5 Malvina Street, Ryde - Proposed Pavillion Building Ryde Secondary College Works

RESPONSE TO REF REQUEST - CITY of RYDE

Project: Ryde Secondary College Works
Location: 5 Malvina Street, Ryde
Proponent: School Infrastructure NSW (SINSW)

Council Reference: CRS2012/8100

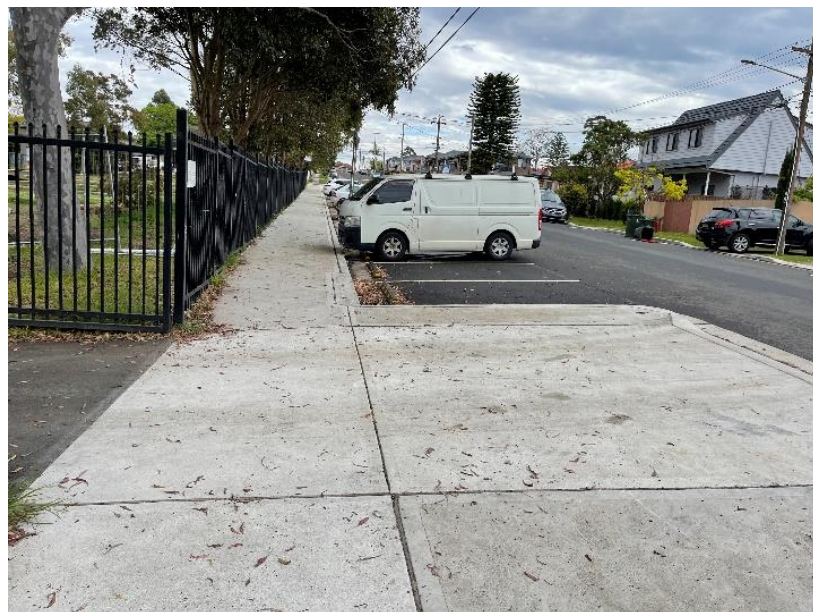
- Malvina Street and Forrest Road have been upgraded as part of the Capital Works Program and works were completed on December 2021, refer photos below.
- Upgraded works include new footpath, kerb and gutter and full width road resurfacing. Also included were the provision of wheel stops to prevent vehicles overhanging onto the footpath.

- Due to the recent upgrade works undertaken by Council, public domain restorations will not be required for the development.
